Brewer Arena Improvements

Parks and Recreation Board
November 13, 2025

Discussion with LASOA & Users

Grandstand & Pavilion

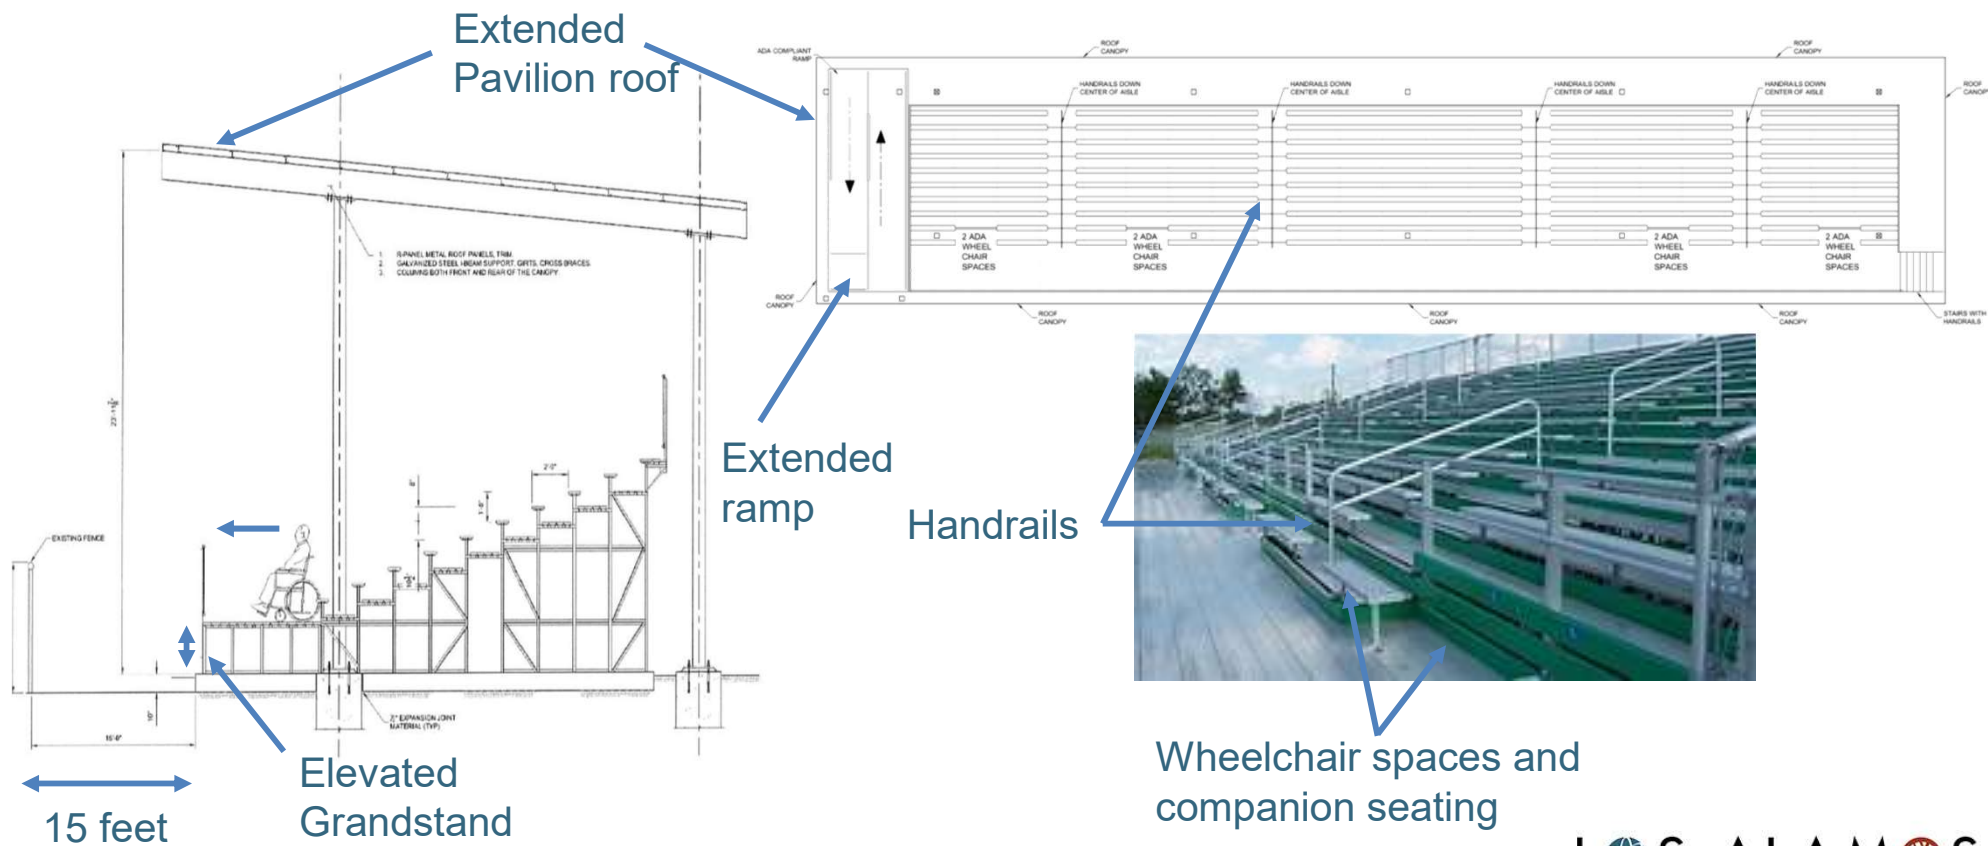
- Adjust elevation so that first row has unobstructed view over arena fence)
- Center the seating on the “50-Yard Line”
- Grandstand to be 15’ away from arena fencing (per PRCA)
 - West side arena access gates need to be unobstructed
- Make seating steps shallower/less steep and with handrails
- Extend the pavilion to provide cover for the entire seating, access ramp, and walkway.

- Increase Grandstand elevation
 - Extend ADA Ramp
- Center Grandstand on the 50-yard line
- Place Grandstand 15’ from arena fence
 - Ensure access gates unobstructed
- Seating incline meets standards
- Enlarge Pavilion

ADA Parking

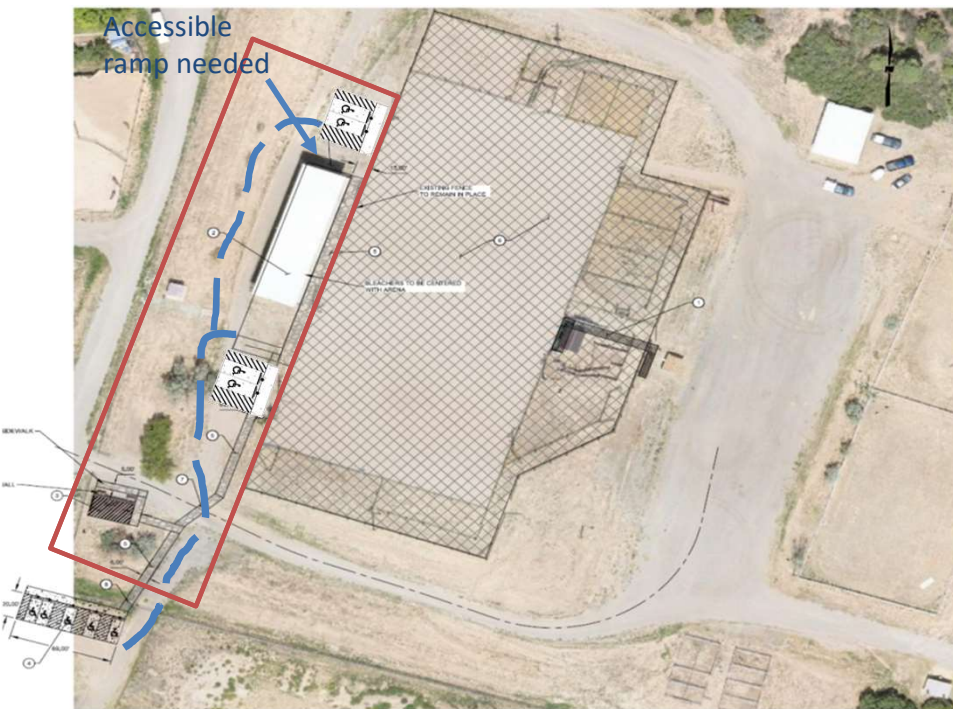
Investigate ADA parking on the north and south of the seating area

- Pros
 - Create a parking that is closer to the grandstand
 - Potentially reduce sidewalk area
- Cons
 - Pedestrian/traffic conflicts
 - Connectors between Grandstand and restroom still needed
 - Vehicle/equestrian flow interference
 - Additional site work required
 - Additional cost
- Recommendation
 - Keep ADA parking on the southside and utilize horse friendly materials on walkway

Restrooms

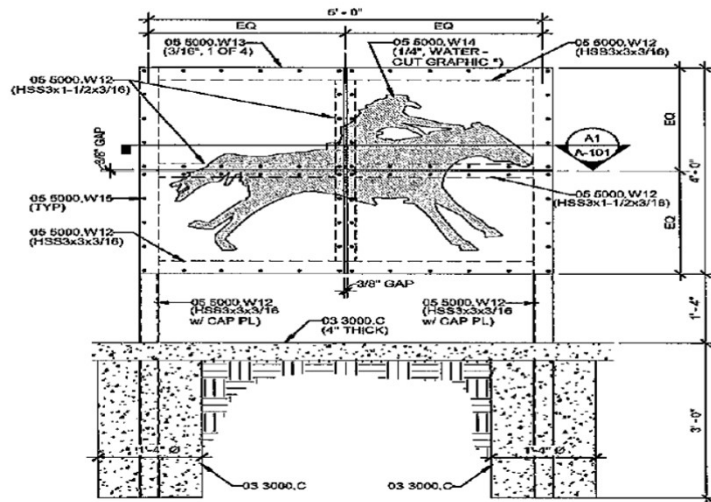
- Sink placement does not allow turnaround wheelchair access
- Restroom capacity will not satisfy the full demand

- Restroom upgrades meet ADA requirements as designed
- Restroom capacity can be increased through the placement of temporary facilities when needed
